Access Compliance Report

Public Rights-of-Way

Intersection ID: N/A	Main Street: SUNSET_RD	Cross Street: N/A	Location: E
ADA ID: 622EF539DE91	Ramp Type: PerpDiag	Initial Pass/Fail: Fail	Overall Compliance: No
		Severity Score: 43.75

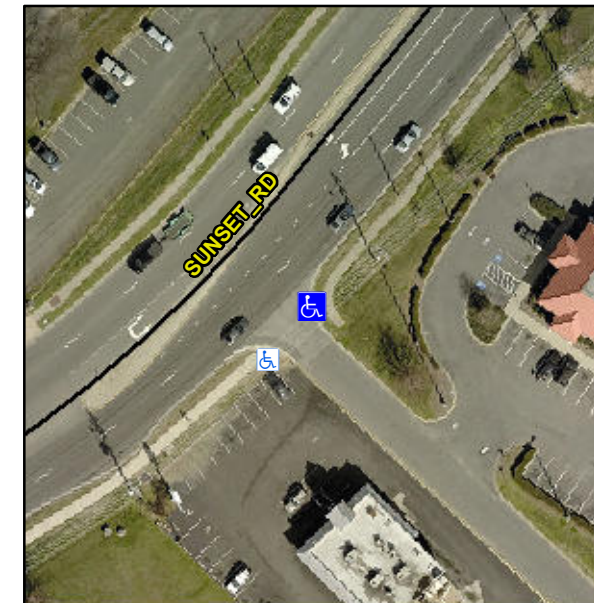
Not Found, R304.5.1, R304.2.2

Compliance	Description	Data	Compliance	Description	Data
N/A	Ramp Length (in)	60.5	No	Ramp Slope (%)	13.3
No	Ramp Width (in)	35.0	Yes	Ramp XSlope (%)	2.2
N/A	Flare Type LT	N/A	N/A	Flare Type RT	N/A
N/A	Flare Slope LT (%)	N/A	N/A	Flare Slope RT (%)	N/A
N/A	Flare Traversable LT?	N/A	N/A	Flare Traversable RT?	N/A
N/A	Landing Length (in)	N/A	N/A	DWS Provided?	N/A
N/A	Landing Width (in)	N/A	N/A	DWS Contrast?	N/A
N/A	Landing Slope (%)	N/A	N/A	DWS Length (in)	N/A
N/A	Landing X Slope (%)	N/A	N/A	DWS Full Width?	N/A
N/A	Landing Curb? (Y/N)	N/A	N/A	DWS Offset (in)	N/A
N/A	Shared Landing?	N/A			
N/A	Gutter Ponding?	N/A	N/A	Gutter Slope (%)	N/A
N/A	Gutter Lip Ht (in)	N/A	N/A	Gutter X Slope (%)	N/A
N/A	Painted X Walk1?	No	N/A	Painted X Walk2?	No
	X Walk 1 Direction	To NW		X Walk 2 Direction	To SW
N/A	X Walk 1 Width (in)	N/A	N/A	X Walk 2 Width (in)	N/A
	X Walk 1 Slope (%)	3.4		X Walk 2 Slope (%)	2.6
	X Walk 1 X Slope (%)	0.0		X Walk 2 X Slope (%)	4.0

Remove & Replace Curb Ramp With Two New Directional Ramps or Equivalent.
